Variance Request Form

Ocotillo Express Wind LLC
Pier 1 Bay 3
San Francisco CA 94111
415-283-4000

Variance: 024
Request No.: Rev 0
Date Submit: 9/26/2012
Date Approval Needed: 9/28/2012
Date Agency Received: _____
Agency Approval Reference No.: _____

VARIANCE 24 - SEPTEMBER 26, 2012

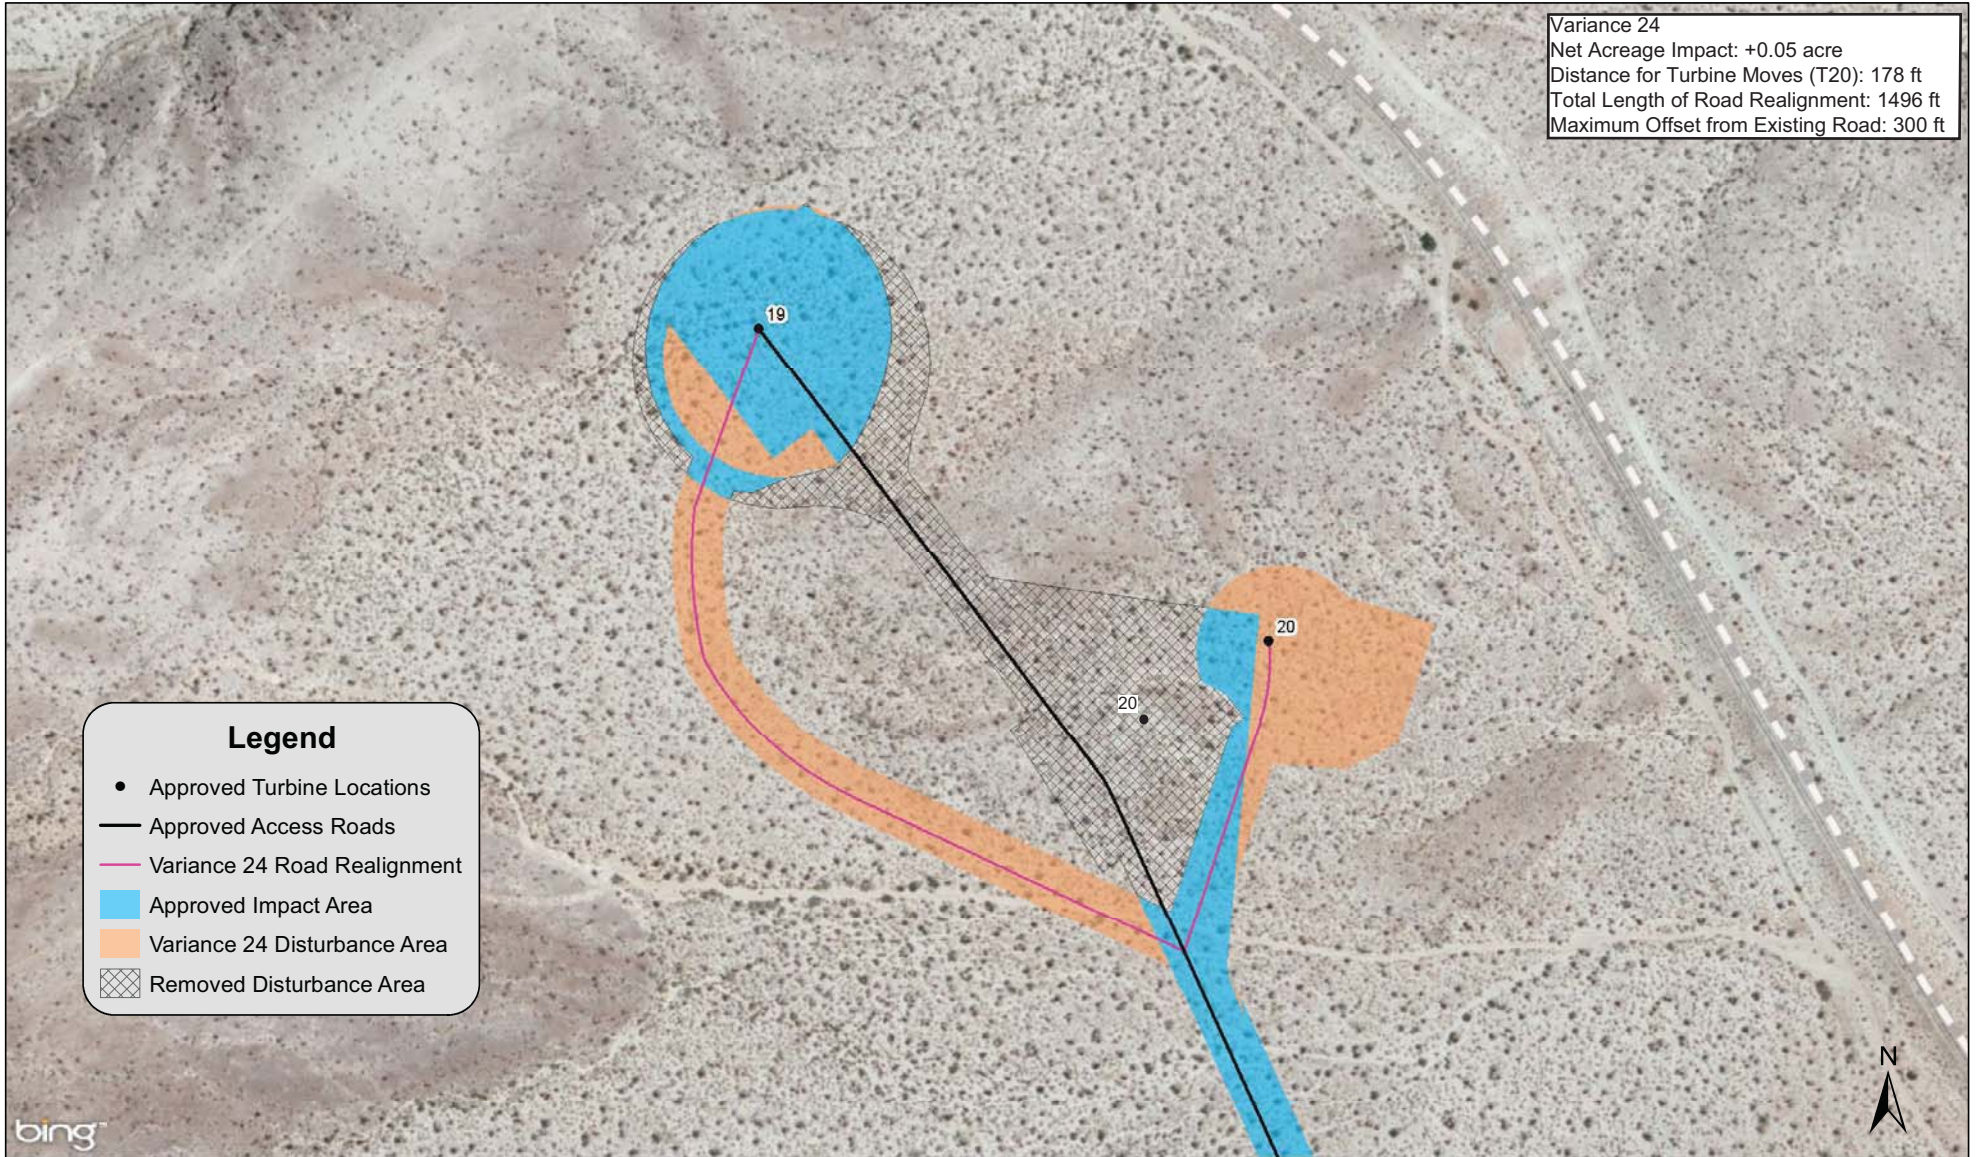
Variance 024 includes the realignment of the access and collection circuit corridors leading towards Wind Turbines 19 and 20. Variance 024 also includes a 178 foot shift of Turbine 20 and modifications to Turbine 19 and 20 pad disturbance areas (see map attachments). The total length of the access and collection circuit corridor realignments are 1496 feet with a maximum offset of 300 feet from the currently approved corridor alignment. The net acreage impacted for the proposed variance is 0.05 acres.

Variance 24
Net Acreage Impact: +0.05 acre
Distance for Turbine Moves (T20): 178 ft
Total Length of Road Realignment: 1496 ft
Maximum Offset from Existing Road: 300 ft
